Access Compliance Report Public Rights-of-Way (Curb Ramps)

Intersection ID: 49185 Main Street: SHARON_HILLS_RD Cross Street: ST_GERMAINE_LN Location: NE

ADA ID: 3EC7CFA3989F Ramp Type: PerpDiag Initial Pass/Fail: Fail Overall Compliance: No Severity Score: 8.75

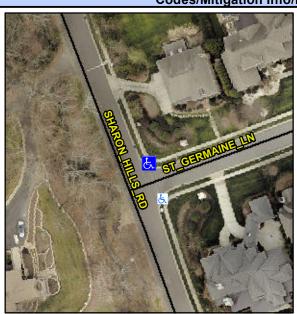
Not Found, R304.5.1

Data	Compliance Description		Data
N/A	Ramp Length (in)	50.0	Yes	Ramp Slope (%)	6.2
No	Ramp Width (in)	46.5	Yes	Ramp XSlope (%)	1.6
N/A	Flare Type LT	N/A	N/A	Flare Type RT	N/A
N/A	Flare Slope LT (%)	N/A	N/A	Flare Slope RT (%)	N/A
N/A	Flare Traversable LT?	N/A	N/A	Flare Traversable RT?	N/A
N/A	Landing Length (in)	N/A	N/A	DWS Provided?	N/A
N/A	Landing Width (in)	N/A	N/A	DWS Contrast?	N/A
N/A	Landing Slope (%)	N/A	N/A	DWS Length (in)	N/A
N/A	Landing X Slope (%)	N/A	N/A	DWS Full Width?	N/A
N/A	Landing Curb? (Y/N)	N/A	N/A	DWS Offset (in)	N/A
N/A	Shared Landing?	N/A			
N/A	Gutter Ponding?	N/A	N/A	Gutter Slope (%)	N/A
N/A	Gutter Lip Ht (in)	N/A	N/A	Gutter X Slope (%)	N/A
N/A	Painted X Walk1?	No	N/A	Painted X Walk2?	No
	X Walk 1 Direction	To W		X Walk 2 Direction	To S
N/A	X Walk 1 Width (in)	N/A	N/A	X Walk 2 Width (in)	N/A
	X Walk 1 Slope (%)	6.6		X Walk 2 Slope (%)	2.8
	X Walk 1 X Slope (%)	4.5		X Walk 2 X Slope (%)	4.4

Remove & Replace Curb Ramp With Two New Directional Ramps or Equivalent.
